Docket Item # 7 & 8
BAR CASE #2012-0290 & 0291

BAR Meeting
September 19, 2012

ISSUE: Certificate of Appropriateness for Alterations and Waiver of Rooftop Mechanical Screening Requirement per Section 6-403(B)

LOCATION: 614-618 King Street

SPACE No. 614 KING ST.
SALES AREA 13,837 SF
NON SALES 5,125 SF
GROSS AREA 18,962 SF
SHEET TITLE:
STOREFRONT
ELEVATION/PARTIAL
PLAN

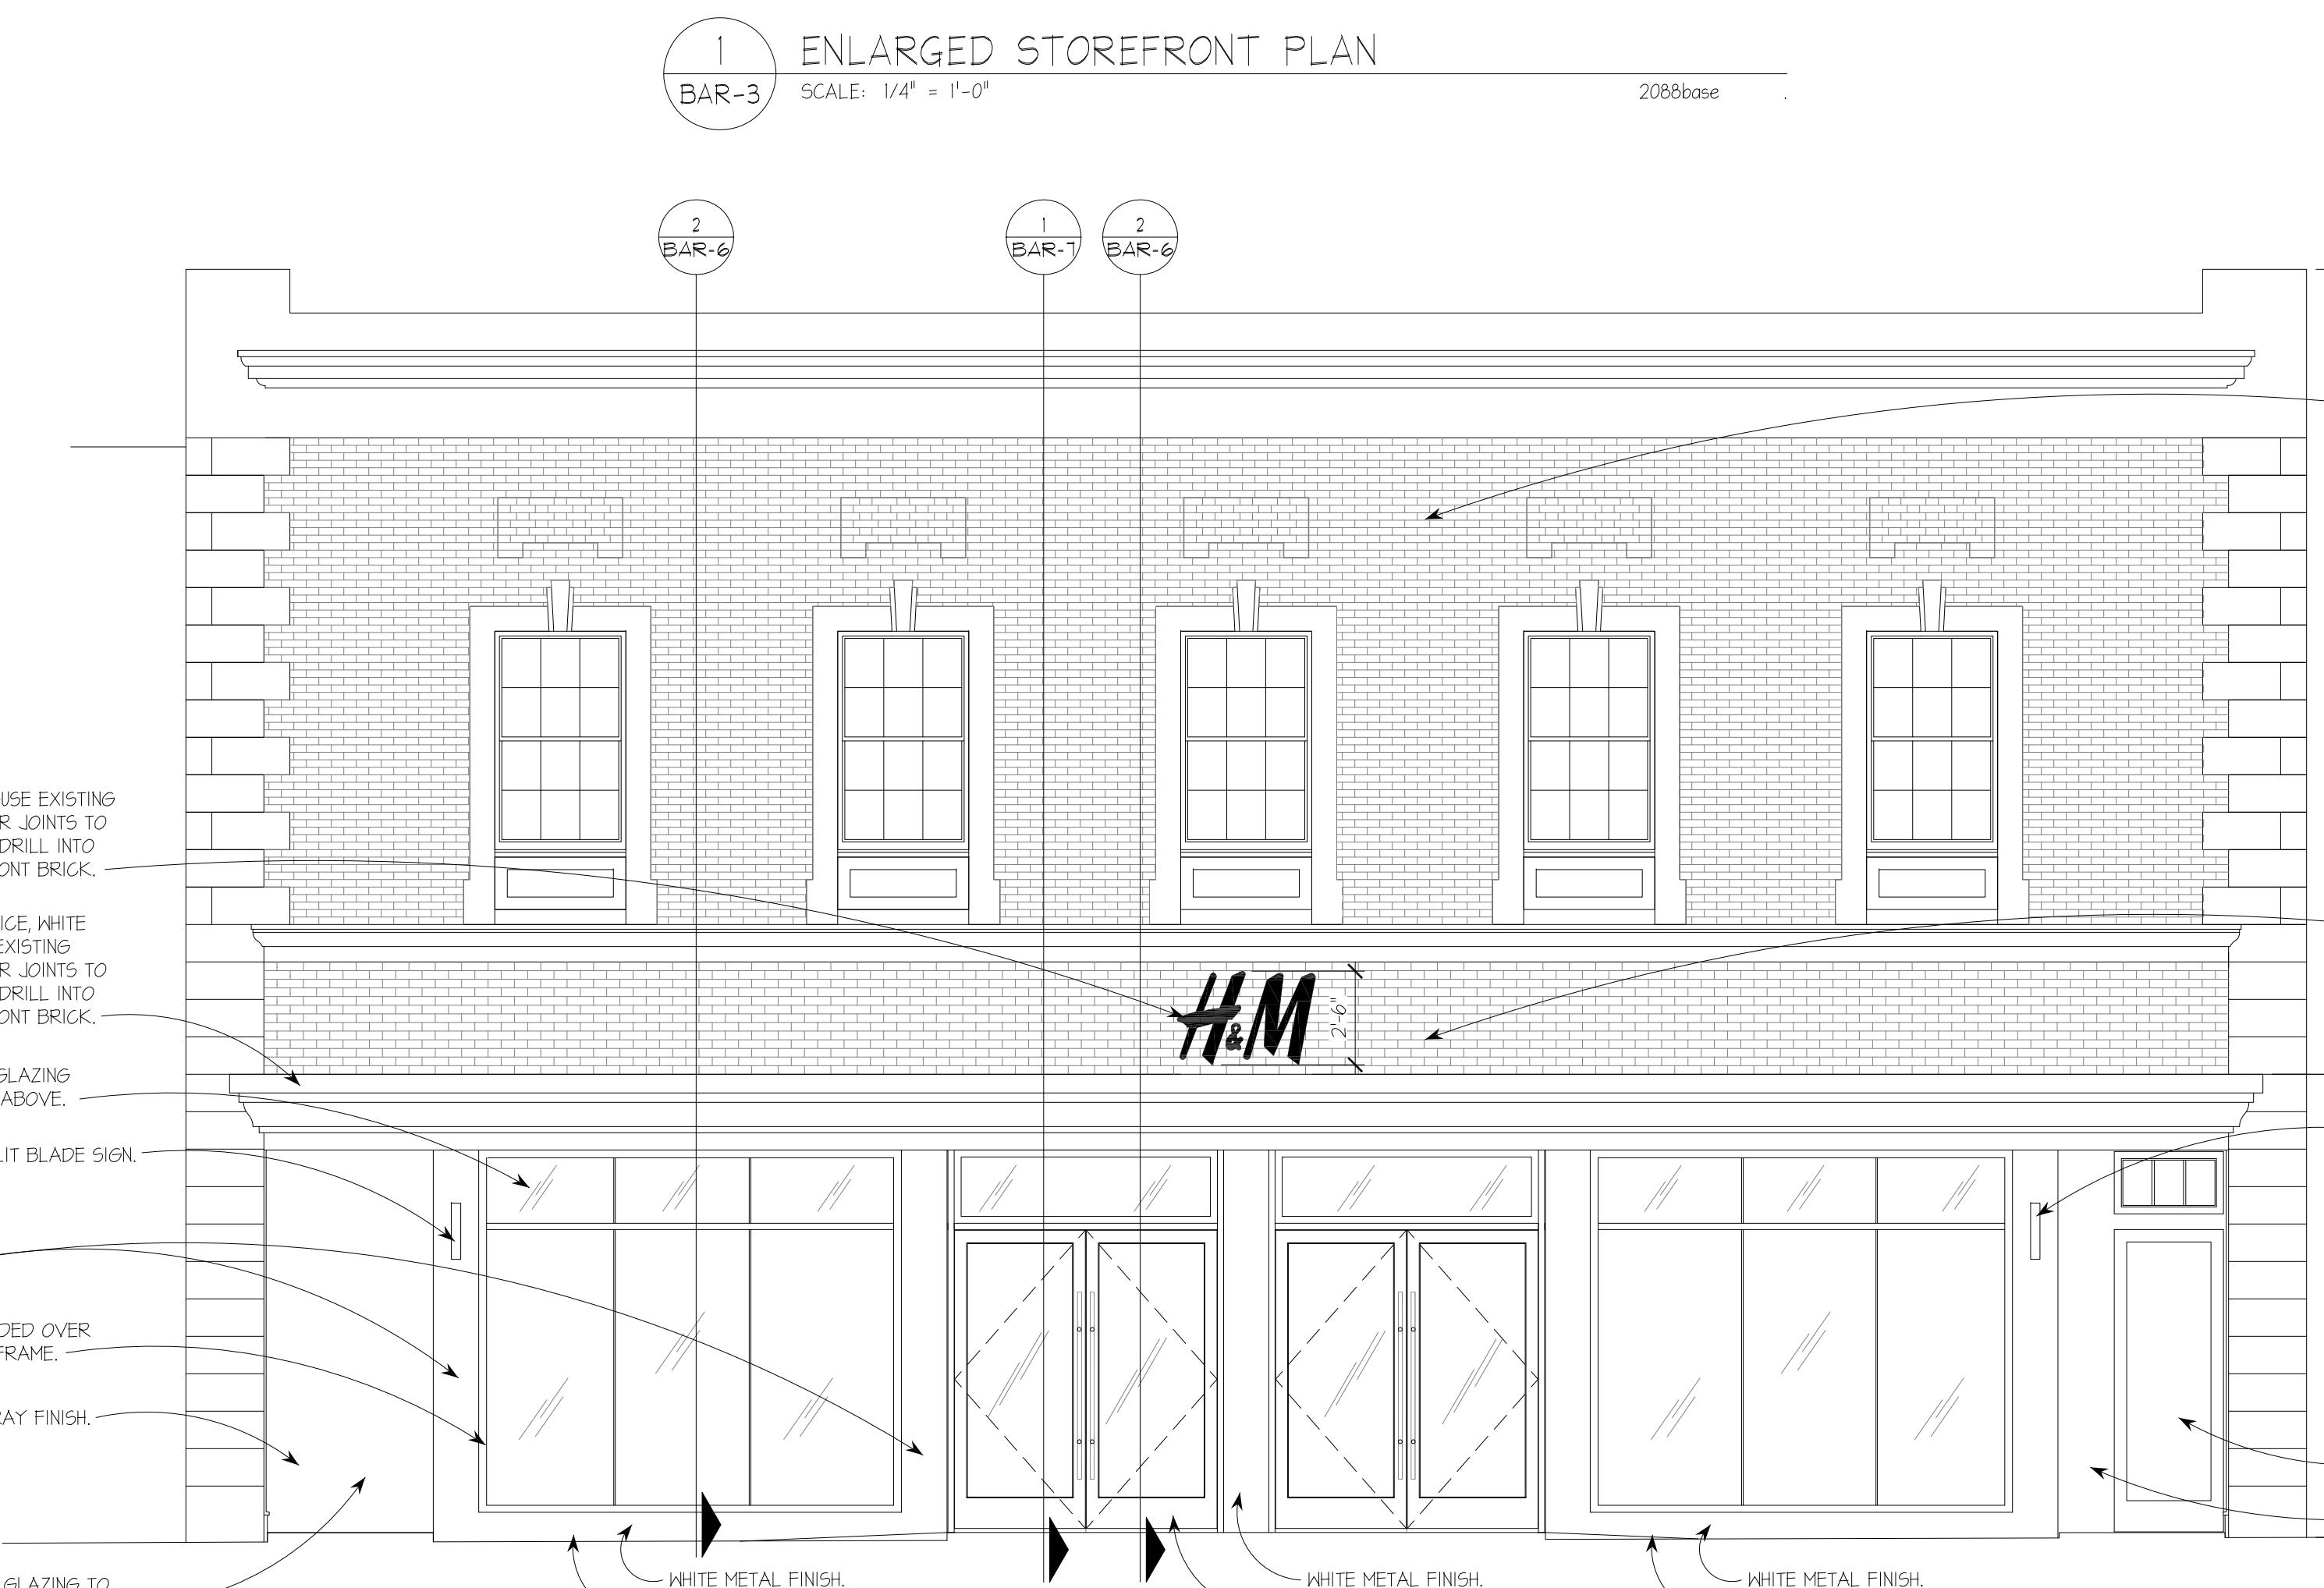
Staff finds that the proposed alterations to the storefront will not damage or negatively impact any of the existing historic fabric above the first floor. The existing cast stone band above the storefront has already been slightly damaged by holes from previous signage and storefront installations. The proposed painted, metal cornice will be mounted over the band utilizing the existing holes and staff finds that this alteration is a reversible, cosmetic change. All of the proposed storefront alterations at grade are easily reversible. Storefronts are commonly revised in response to changing public taste and retail trends and the proposed alterations will not damage the historic building façade above.

C-2 The store fronts still appear blocked with white screens and there are signs located in the windows which will count towards the total square footage of signs allowed. The window signs may exceed the maximum of 20% of a window and appear to be special advertising which is not permitted.

Exterior Signage

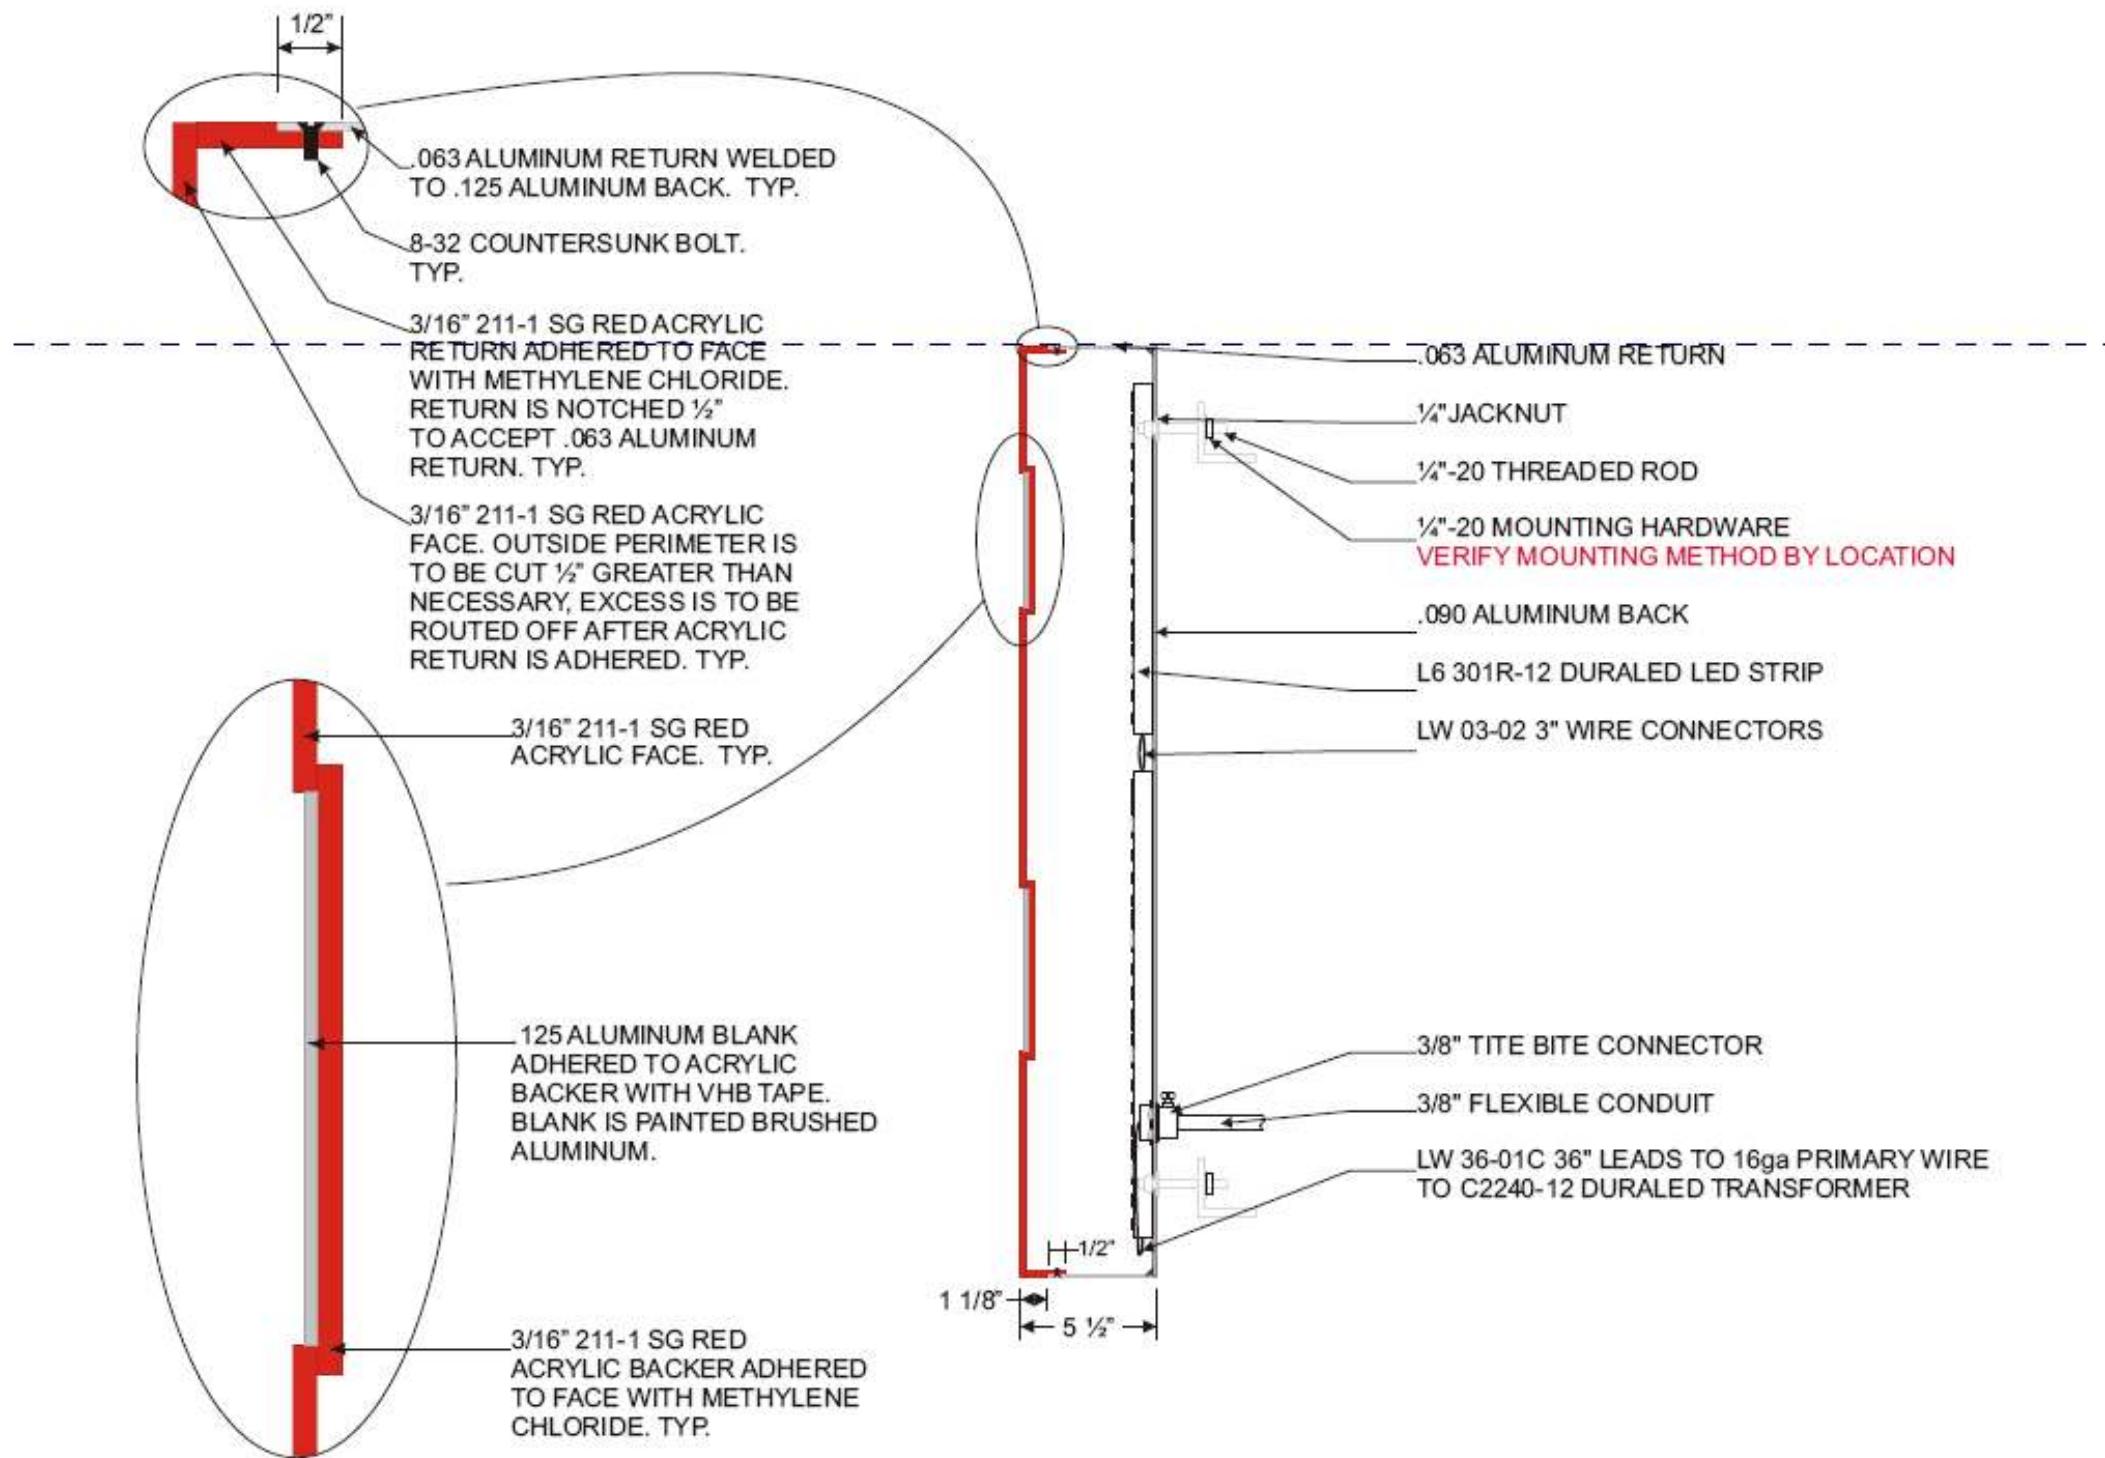
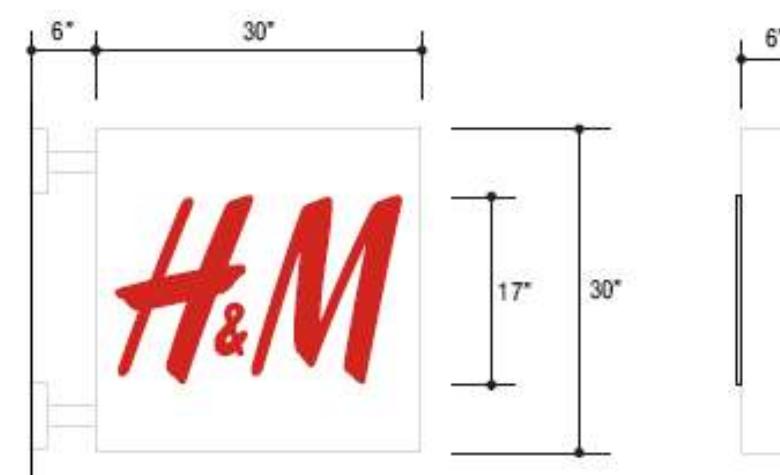
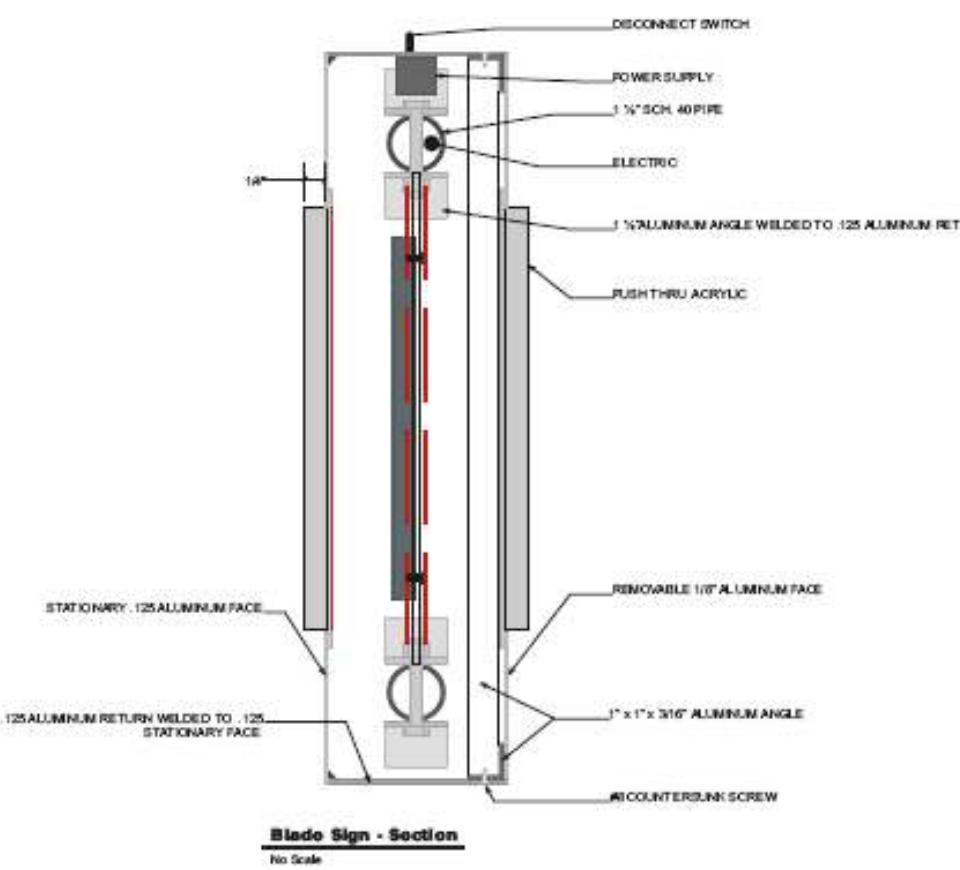
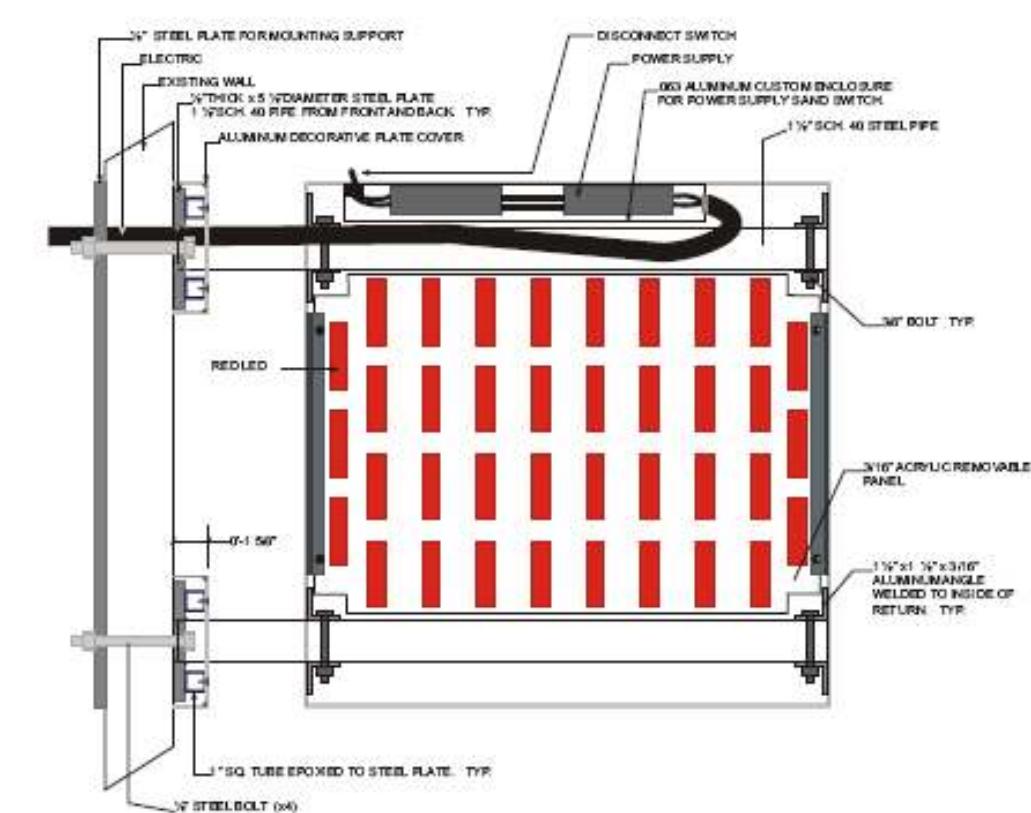
Staff recommends approval of the Certificate of Appropriateness with the condition that the signs are not internally illuminated. If the applicant desires to illuminate the signs they will work with staff on a design which utilizes external illumination using gooseneck or mini-spot lights.

The *Design Guidelines* recommend that one sign per business is generally appropriate. However, the Board has frequently approved more than one sign for a business with a single frontage. The signage typically is a combination of projecting hanging, wall mounted lettering and/or window decals. Due to this large storefront’s location on King Street and the types of signs approved for nearby businesses of similar scale, staff believes that three small signs totaling approx. 22 sq. ft. are appropriate for this business. However, Staff finds the illumination of the signs to be inappropriate, as the Board’s *Design Guidelines* discourage internally illuminated signs. The Board emphasized that internally illuminated and halo illuminated signs were inappropriate on historic buildings during the Burke & Herbert bank case across the street several months ago. Should the Board support external illumination of the signs, Staff recommends minimally visible LED spotlights mounted on conduit arms, similar to those used at the Gap next door and for the previous Restoration Hardware sign lights. The proposed signage is otherwise generally consistent with the *Design Guidelines* in design, material and scale and is appropriate for the architectural character of 614 King Street and this section of the historic district.
